Subject: INFORMATION DISPLAY SHOWS "FOW INSPECTION REQUIRED" AND DTC C1A67:78 IS STORED	Bulletin No: 01-029/13
	Last Issued: 11/27/2013

2014 Mazda6 vehicles with VINs lower than JM1 GJ ***** 149082 (produced before October 01, 2013)

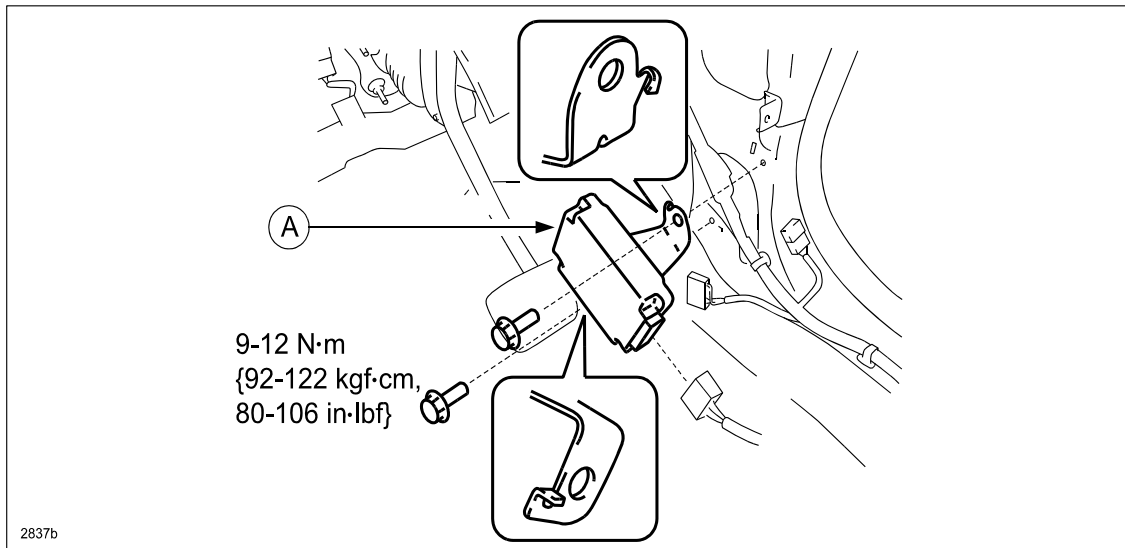
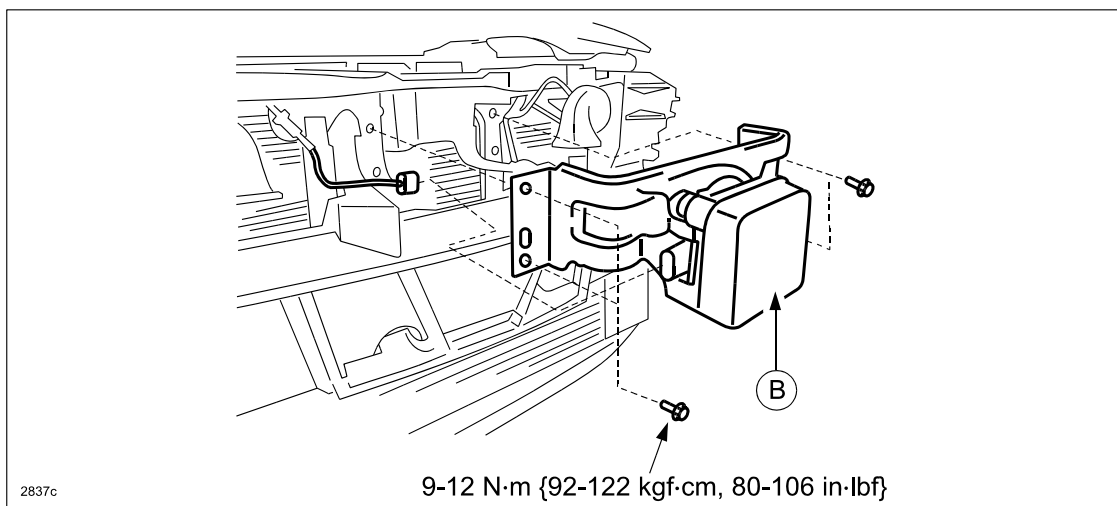
1. Verify customer concern.
2. Replace the vehicle control module (A) and radar sensor (B). Refer to MS3 online or Workshop Manual section 01-20:
 - VEHICLE CONTROL MODULE (V/C-MODULE) REMOVAL/INSTALLATION [MAZDA RADAR CRUISE CONTROL (MRCC) SYSTEM]

- RADAR SENSOR REMOVAL/INSTALLATION [MAZDA RADAR CRUISE CONTROL (MRCC) SYSTEM]

3. Perform the radar sensor aiming adjustment. Refer to MS3 online or Workshop Manual (section 01-20 RADAR SENSOR AIMING [MAZDA RADAR CRUISE CONTROL (MRCC) SYSTEM]).
4. Verify repair.
